CLIFF BUNGALOW-MISSION COMMUNITY ASSOCIATION

Re: **LOC2018-0250**, 617 17 Avenue SW (Multiple Addresses)

Decision: **Objection¹**

Exhibit 1. Density map of the Beltline shown in shades of blue, with the area of Cliff Bungalow with an FAR of 2.5x is shown in pink. This exhibit illustrates how density steps down from an FAR of 8.0x on 10 Ave SW, to 5.0x at 13 Ave SW to 3.0x at 17 Ave SW to 2.5x in Cliff Bungalow.

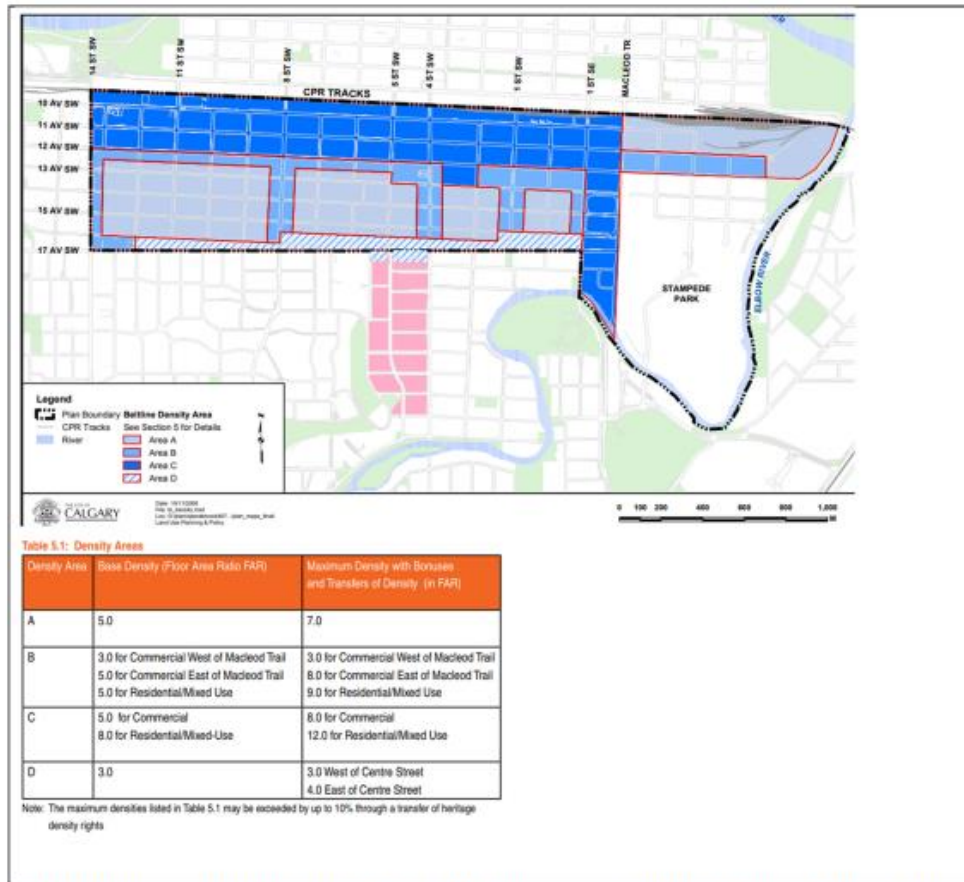
This is illustrated in the map and table below, which show the step down of density through the Beltline from the North (near the downtown core) to the South (as it leads into lower-density neighbourhoods). The major thoroughfares close to downtown (between 10th Avenue SW and 12th Avenue SW demarked as Area C on the map below) have a base FAR of 8.0x for residential uses. Moving south, this allowable density then steps down between 12th Avenue SW and 15th Avenue SW (Area A), which has a base FAR of 5.0x. And going further south, the density then steps down further along 17 Avenue (Area D with a base FAR of 3.0x). And finally, to the south of 17 Avenue within Cliff Bungalow, the FAR steps down to 2.5x. *Given this context, stepping up from an FAR of 3.0x along 17 Avenue to an FAR of 6.0x in Cliff Bungalow is not justifiable using the planning application of density step-downs.*

Given the context outlined above, stepping up from an FAR of 3.0x to an FAR of 6.0x is not justifiable using the application of placing incremental density along major thoroughfares.

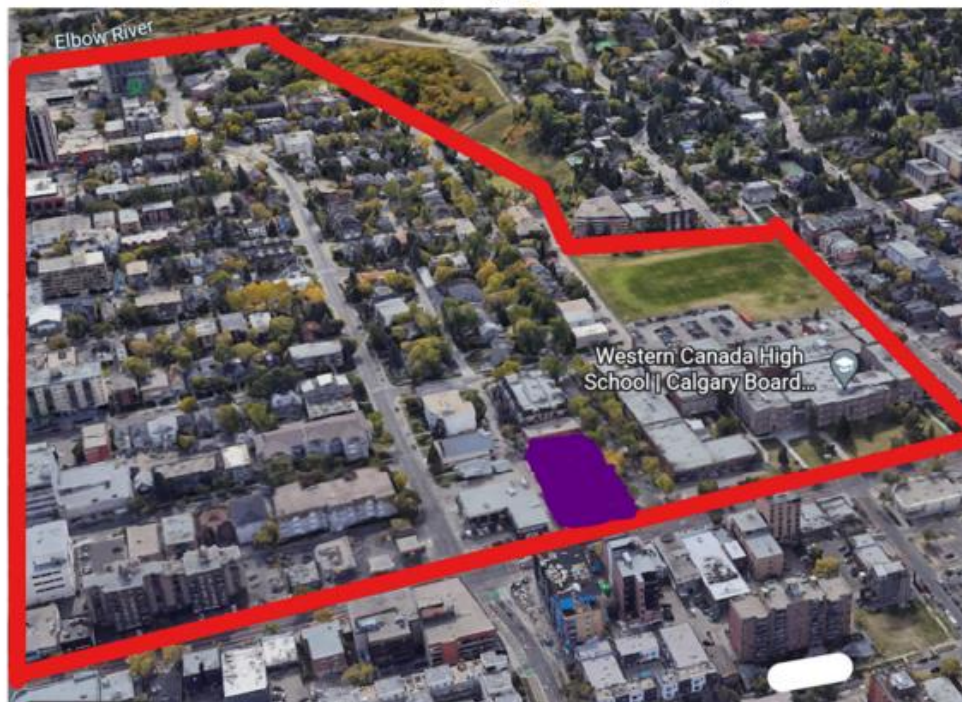
The neighbourhood of Cliff Bungalow is a historical community characterized predominantly by pre-WWI houses and sensitive densification that has primarily entailed the development of townhomes and small multi-family complexes (3-6 stories) within the neighbourhood. Given this context, a 15-storey tower would look substantially out of place, both with respect to the existing character of the neighbourhood and with respect to the community's approach to sensitive densification. This is illustrated below in a photograph of the community.

The Cliff Bungalow ARP notes that one objective for Residential Land Use is to “preserve and enhance the established low to medium density character.” A fifteen-storey tower does not align with this objective. A second objective is to ensure that housing, both new and redeveloped, is architecturally compatible with the existing residential character of the community. Once again, a fifteen-storey tower, does not align with this objective. Within the Medium Density Policy, the ARP notes that “The design of new developments should reflect the character of the original community.” Once again, a fifteen-storey tower does not reflect the character of the original community that was developed through the early-twentieth century.
